Revised Development Strategy Response Form 2013

WARWICK DISTRICT LOCAL PLAN

DETAILED COMMENTARY AND OBJECTION

Critique of the AQMA Analysis

Inbound Traffic and Congestion 2003, 2006, 2008, 2010

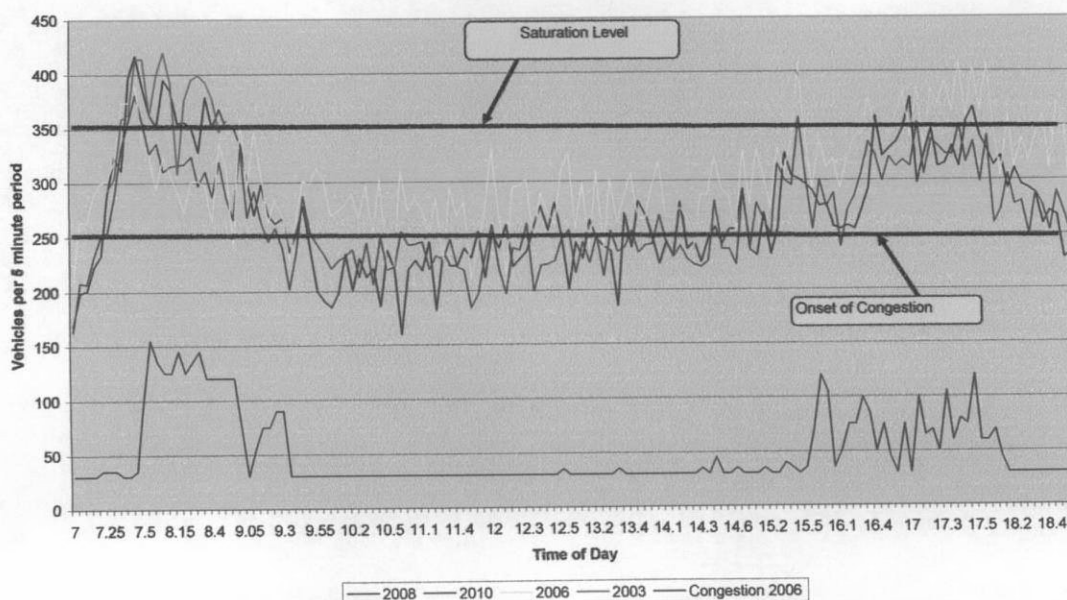
The accompanying Figure shows the recorded traffic flows between 2003 (Warwick Society) and 2010 (WCC), together with the WCC’s record of congestion incidents in 2006. All show a similar pattern, which may be interpreted as follows:

- a. A morning “rush” to beat later congestion, commencing about 07.15. This can be shown in the more detailed (street-by-street) analysis to begin in St Johns inbound, presumably to beat congestion on Castle Hill.
- b. A peak period lasting until about 9am when traffic saturates at about 4200 vph
- c. A period of “normal” but heavy flow with occasional congestion events until about 15.30.
- d. The afternoon peak is in two stages, beginning at about 15.30 with the “schools out” traffic and ending about 16.15. At 16.45, there is a second peak lasting until about 18.00. During these periods individual roads (eg Smith St) become congested, but overall the town centre is not saturated.

The morning peak is focused on drivers reaching their destinations (school, business) by 9am, and it may be assumed that this will continue to be the case. It may also be assumed that drivers will not want to begin their journeys any earlier, leading to the conclusion that additional traffic demands from new housing developments will in general find alternatives.

Conclusion – Warwick’s morning peak traffic will be largely unaffected, hence “mitigating measures” are not required.
